SEWAGE DISPOSAL SYSTEM

MARYLAND STATE DEPARTMENT OF HEALTH

SUBDIVISION Hallowell Property ROAD Florence Rd. - Rt. 10 LOT 10

PROPERTY OWNER Joseph G. Ciufolo

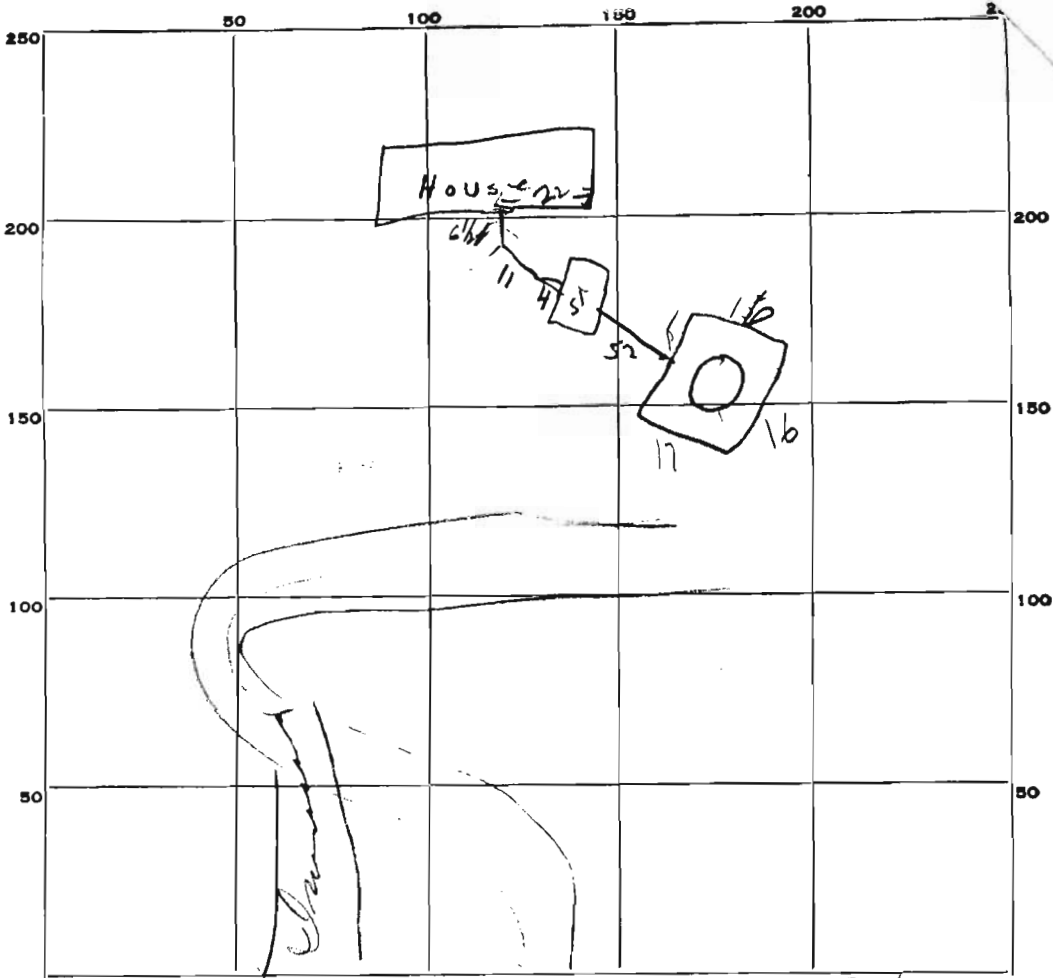
OTHER Dry well - 16 ft. square (set block and top for 12 ft. diameter and fill in rest of pit with gravel). Dry well to be 7 ft. deep below the inlet pipe. Inlet pipe must be 4 ft. below original grade. Maximum depth permitted for dry well below original grade is 13 ft. Place dry well 75 ft. directly in front of right front corner of house.

REMARKS 11/16/67 Due to amount of rocky soil can't open space between outlet pipe & solid ground the first 5 ft of fiber pipe should be removed & replaced with cast iron - fiber pipe may bend when ground settles or cracks in pot hole in it when backfilled - or use extreme caution when must be used in backfilling & backfilled to hard - then tamped light fiber pipe should be braced by plank board not necessary to call for rock bed
